In the Drawing

REMARKS

Voluntary amendment to the Drawing

FIG. 5

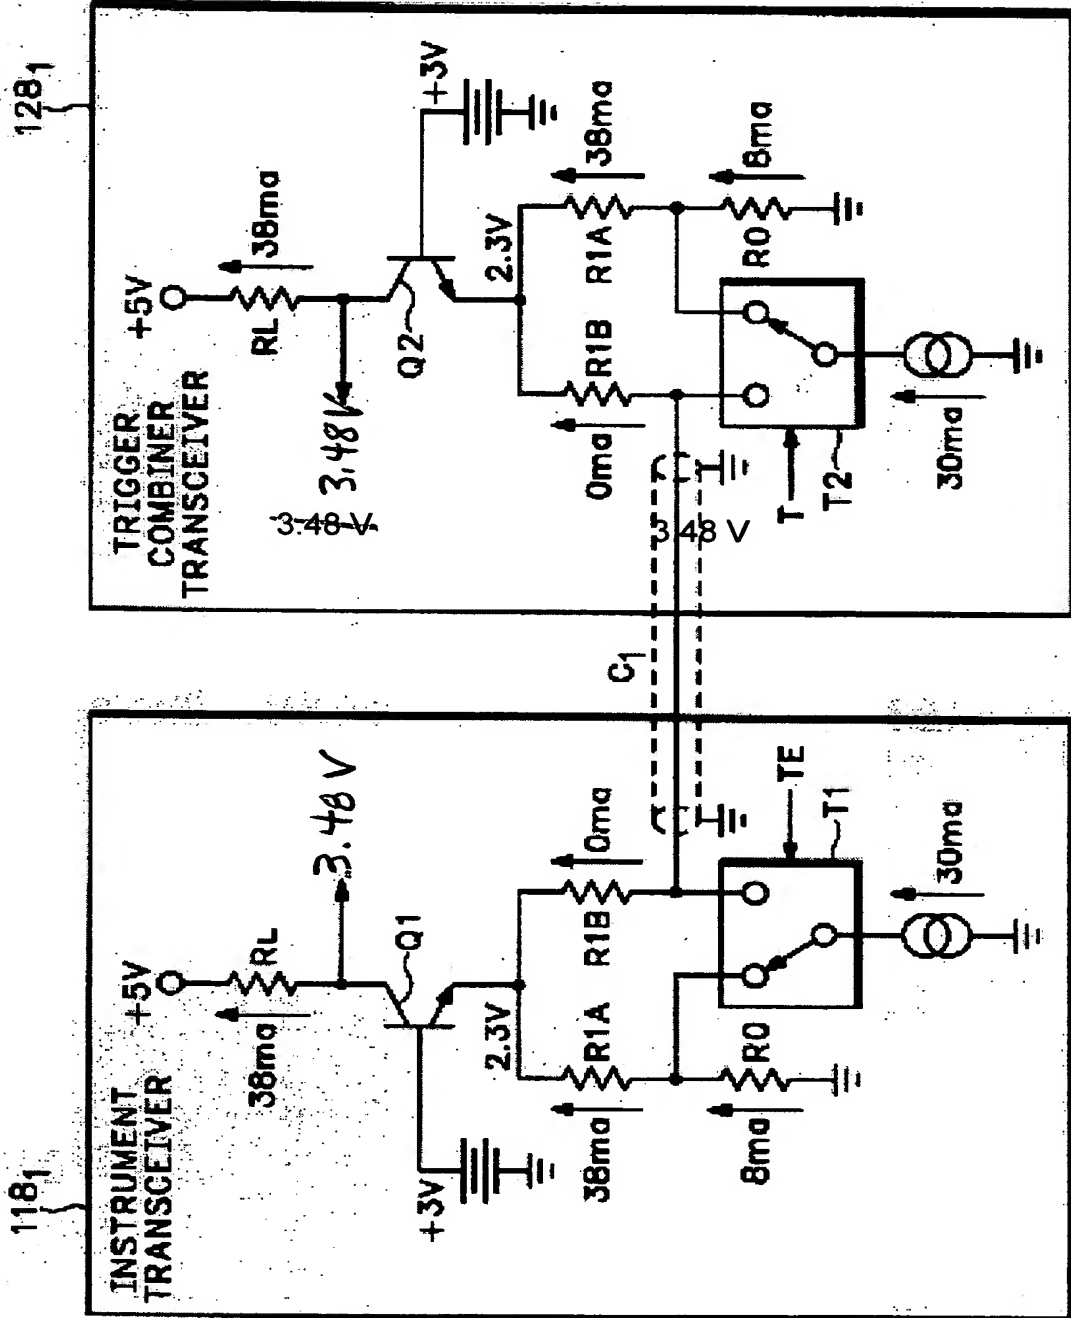
With respect to FIGURE 5, it can be seen from the corresponding calculations on page 15, lines 26-28, that the voltage at the collector of Q1 should be labeled "3.48 V". Also, the upper occurrence of the "3.48 V" text in the right-hand side of the FIGURE 5, has been rotated 90 degrees for easier reading. The lower occurrence of the "3.48 V" text in the right-hand side of the FIGURE 5, has been deleted.

Similarly, RL is said to have a value of 40 ohms. 38 ma through 40 ohms causes a voltage drop of 1.52 volts. Therefore, the voltage at the collector of Q1 should be (5v -1.52 v = 3.48v), not 3.1 volts, as incorrectly typed. The correct voltage of 3.48 V is shown in FIGURE 5 as filed.

FIG. 7

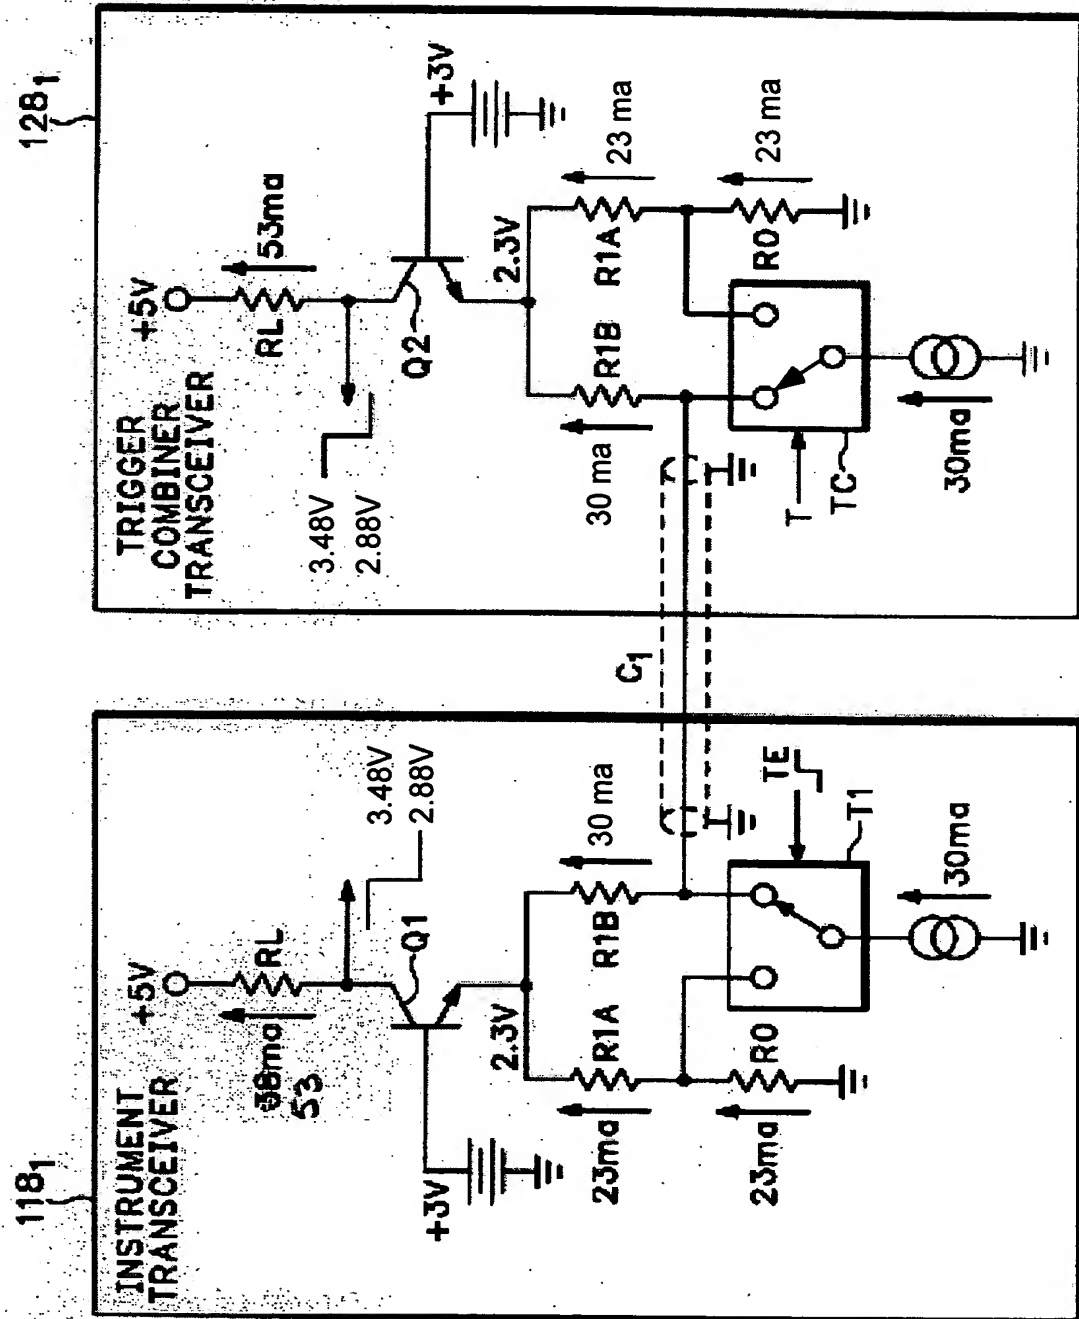
With respect to FIGURE 7, it can be seen from the corresponding text on page 16, lines 17-19, that the current through RL should be labeled "53 ma".
